MACK TRUCKS, INC.

**SAFETY RECALL ALERT**

**Bulletin:** SRA-M13-04  
**Date:** October 24, 2013  
**Replaces:** N/A  
**Action:** **YES**

**Subject:** Safety Recall, SC0372, Cross Steering Tube Clamp (Tie Rod)

Pinch Bolts

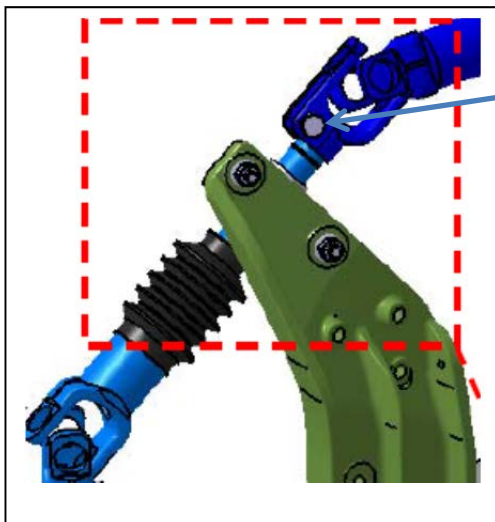
1. The upper and lower pinch bolts must be replaced. Refer to the picture below.

On certain models, there may be two shafts (see illustration). For this configuration, replace all three pinch bolts.

Possibility of 3<sup>rd</sup> Pinch Bolt on certain models; for this configuration, 3 pinch bolts must be replaced.

2. Replace pinch bolts and nuts. Torque to 95 Nm (70 ft-lbs).

Parts Required: Pinch Bolt (Part # 25106380); nut (Part # 25098472)
